South Texas Project Electric Generating Station P.O. Box 289 Wadsworth, Texas 77483

U7-C-STP-NRC-100127

South Texas Project
Units 3 and 4
Docket No. PROJ0772
Response to Request for Additional Information

Reference: Letter from Tekia Govan to Mark McBurnett, "Request for Additional Information Re: South Texas Project Nuclear Operating Company Topical Report (TR) WCAP-17079-P Revision 0, Supplement 3 to Bison Topical Report RPA 90-90-P-A SAFIR Control System Simulator" (TAC No. RG0012), March 12, 2010

Figure 8 Brief description of ABWR model

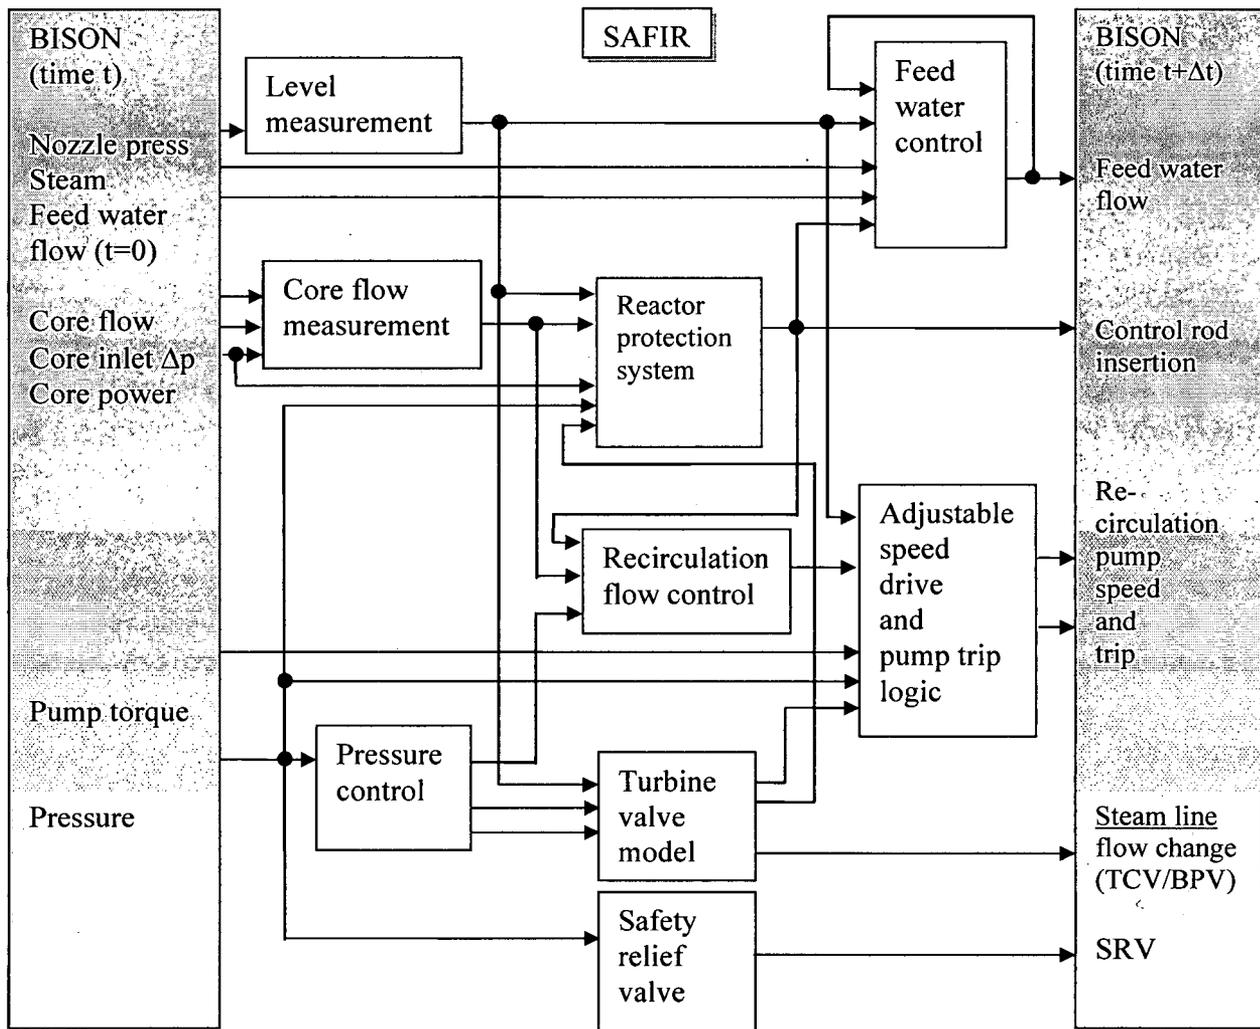
State whether the set of transient events for which BISON-SAFIR will be used is the same as that defined in CENPD-300-P-A. If there are any additional transient events for which BISON-SAFIR is intended to be used beyond the set originally defined for BISON, and then describe in accordance with the requirement the additional transients events for which BISON-SAFIR will be used.

A brief description of SAFIR models used during an example transient (Feedwater Controller Failure – FWCF) and the main connections between models is presented in Figure 1. The analysis results, as calculated in BISON, shown in Figures 2 through 7, demonstrate the capability of BISON-SAFIR methods to determine a transient scenario.

Figure 1 of the response to RAI-15 shows a description of an ABWR model and the interaction of SAFIR with BISON. RAI-15 (Figures 3, 5 and 6) shows examples of BISON responses (recirculation pump speed, steam line flow, and control rod insertion) with SAFIR calculated boundary conditions.

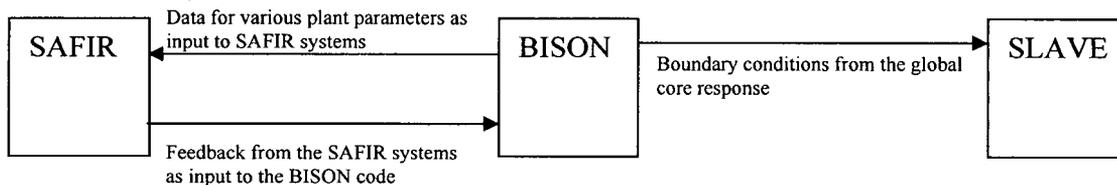
- b) Originally BISON, along with the hot channel analysis code SLAVE, were approved for licensing of reload transients used in fuel reload analysis. Describe how SAFIR affects the hot channel analysis performed using BISON-SLAVE. Describe any input and output signals shared directly between SLAVE and SAFIR.

The hot channel analysis with SLAVE utilizes boundary conditions from the BISON determined global core response such as pressure, core pressure drop, fission power and enthalpy to determine the plant response within a single fuel bundle. The SLAVE code does not interact with SAFIR and thus no input and outputs are shared directly between SAFIR and SLAVE.

A schematic figure on how the codes interact is shown below. As can be seen in the figure, SAFIR and SLAVE do not interact directly.

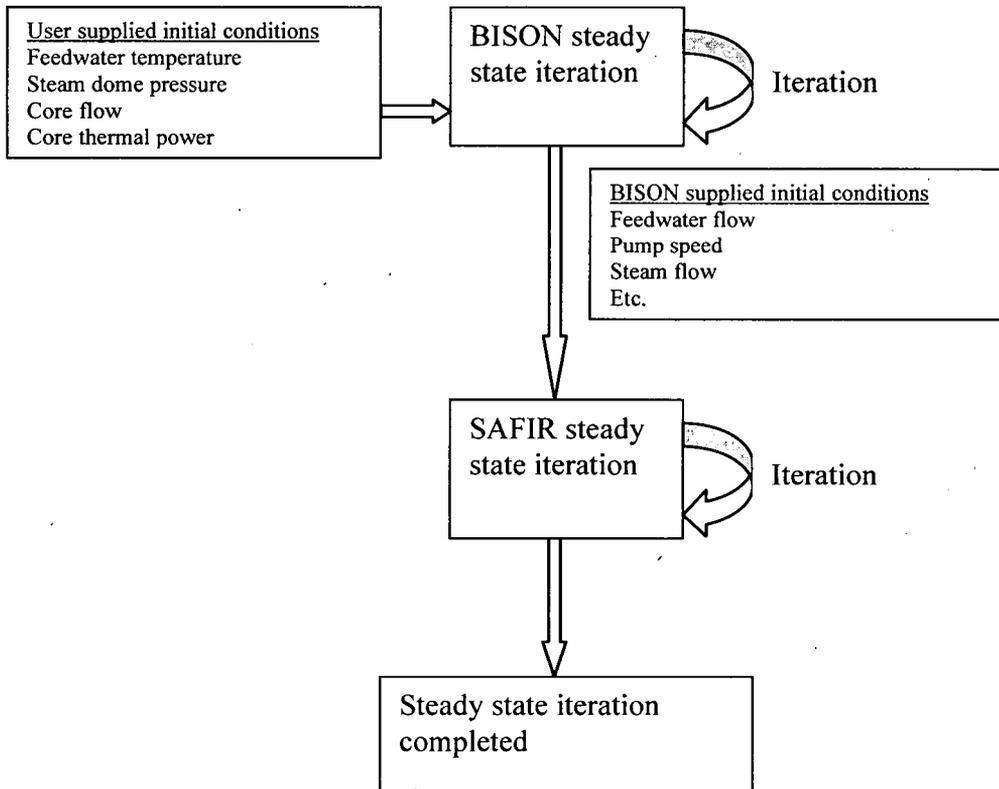
- c) Demonstrate that the introduction of the SAFIR capability has not changed the previously approved performance capability of BISON-SLAVE (i.e., that an input to BISON-SAFIR that uses no SAFIR components performs identically to the same input to the previously approved BISON code).

18 c) SAFIR and SLAVE do not share any input or output signals directly. The SAFIR code generates the response of control systems during a transient or the initiating event itself (if it is a control system malfunction) as input to the BISON code. BISON calculates the global core response during the transient and SLAVE calculates the hot channel response using BISON global core response.

Control systems affect the core in the sense that systems feedback influences the sequence of events during the transient, but this would be the case whether the input is provided as a boundary condition or as a more flexible and robust model using SAFIR.

The parameters describing the core response such as pressure, core pressure drop, fission power and enthalpy remains unaffected by the introduction of SAFIR capabilities in the BISON context.

Figure 9 Signal flow during a BISON time step for trip detection

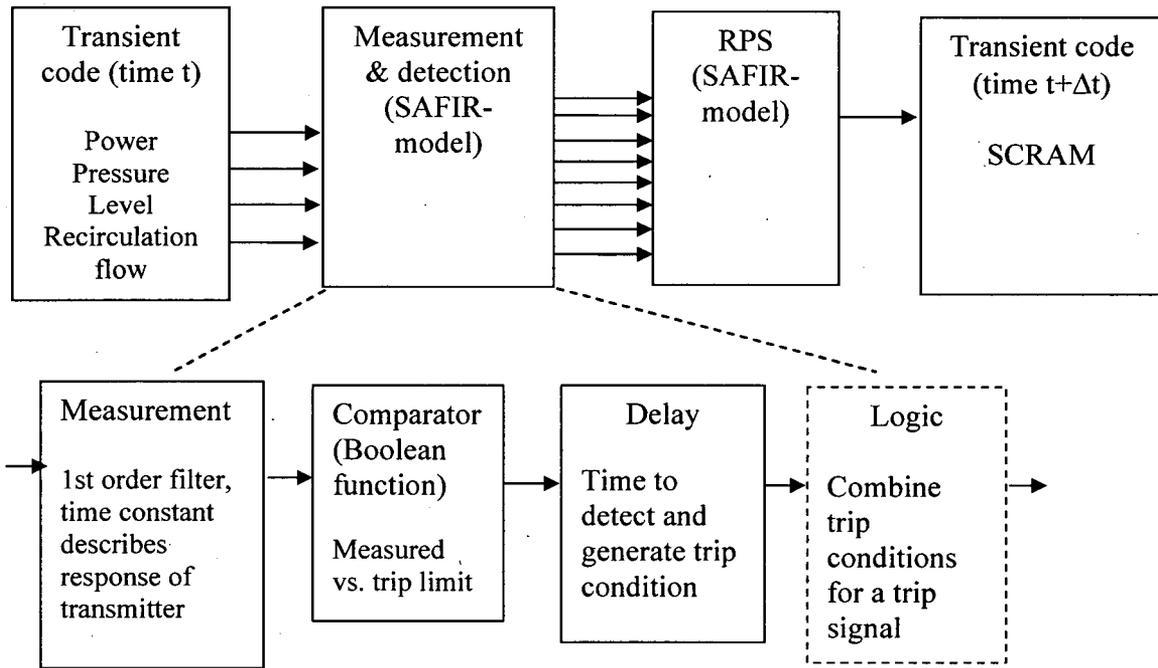
Identify and describe the input models for any of these trips that may be modeled using the new SAFIR capability of the BISON-SAFIR code. Include a description of the signals at the BISON-SAFIR interface that are used in modeling these trips.

Figure 1 below shows the process by which BISON interfaces with SAFIR to model a reactor trip. This is an example intended to describe the process, but the information that is passed from BISON to SAFIR is dependant on the situation. The first box is BISON's input to the SAFIR Measurement & Detection model. Statepoints calculated in BISON for each time step are sent to SAFIR. In this example the SAFIR model is composed of a measurement, comparator, and delay components. The addition of a logic component is optional in SAFIR, and is dependent on the situation. The output from the Measurement & Detection model goes to the Reactor Protection System (RPS) model in SAFIR. The RPS model in SAFIR determines if a setpoint has been exceeded, and will provide input of either scram or no scram to BISON. This is done at each time step for BISON.

The process would not change the transient analysis performed by BISON and thus not impact any safety analysis results calculated within BISON. SAFIR would act as a logical component to determine if plant conditions exceed any boundary conditions which would trigger a reactor scram and communicate those results to BISON.
